DOCUMENT 009113.01 – ADDENDUM 01

A. Project Name: East Grand School District – East Grand MS

EAST GRAND SCHOOL DISTRICT
East Grand Middle School Renovation Summer 2026
251 W Diamond Ave
Granby, Colorado 80446

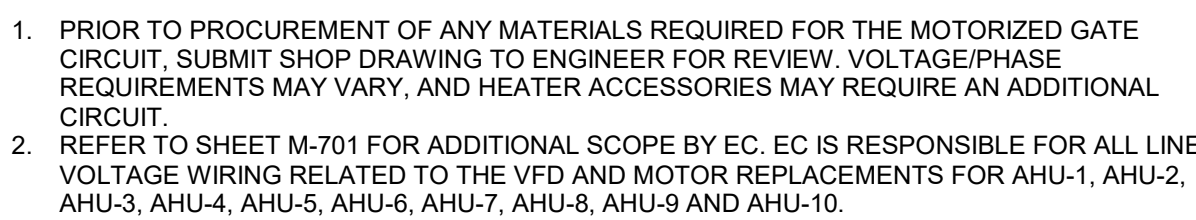
- 1. Revision to sheet M-601
 - a. Removed existing air handling unit refurbishment schedule.
- 2. Revision to sheet E-211.2
 - a. Revise keynote 2222.

- A. Contractor Comments Provided by FCI Constructors on February 25, 2026.
 - 1. Comment: Electrical drawing E-211.2 appears to be showing the power routing for one of the motorized gates shown on the MPHS site plan. Please clarify if this electrical scope is to be shown as part of the MPHS scope, or if the motorized gate is to be included with the EGMS scope
 - a. IMEG response: The gate on E-211.2 is EGMS scope. The gate near the press box is MPHS scope.
 - 2. Comment: DD phase pricing for the fabric shade structure on sheet LS101 was based on a different drawing sheet provided to FCI separately for budgeting. Please confirm the shade structure and manufacturer shown on LS101 is to be priced and included per the CD drawings and not the design budgeted during the DD phase.
 - a. The shade structure and manufacturer indicated on the CD drawings should be priced and included.

2219 ROUTE NEW CONDUIT OVERHEAD IN PLENUM FROM PANEL TO BUILDING EXTERIOR.
ALL SLEEVES IN WALLS TO MATCH EXISTING FIRE RATING.

2220 TRANSITION THROUGH EXTERIOR WALL, AND THEN VERTICALLY DOWN TO GRADE
WITH 1" FITTING AND GRC AT 2' BELOW GRADE. TRANSITION TO SCH 40 PVC

- 2219 ROUTE NEW NDUIT OVERHEAD IN PLENUM FROM PANEL TO BUILDING EXTERIOR. ALL SLEEVES IN WALLS TO MATCH EXISTING FIRE RATING.
- 2220 TRANSITION THROUGH EXTERIOR WALL, AND THEN VERTICALLY DOWN TO GRADE WITH LB' FITTING AND GRC. AT 2' BELOW GRADE TRANSITION TO SCH 40 PVC.
- 2221 UTILIZE SPARK 120V 20A/1P BREAKER. IF NOT AVAILABLE, INSTALL NEW BREAKER IN SPACE. IF NO SPACE IS AVAILABLE, CONSULT WITH ENGINEER.
- 2222 NEW MOTORIZED GATE OPERATOR. PROVIDE DEDICATED 120V 20A CIRCUIT. COORDINATE WITH MANUFACTURER ON ROUGH-IN REQUIREMENTS INTO BASE/LEAVEOUT. WIRE WITH 2#12 + #12G IN 3/4". REFER TO SHEET A-100 FOR LOCATION AND ADDITIONAL INFORMATION.
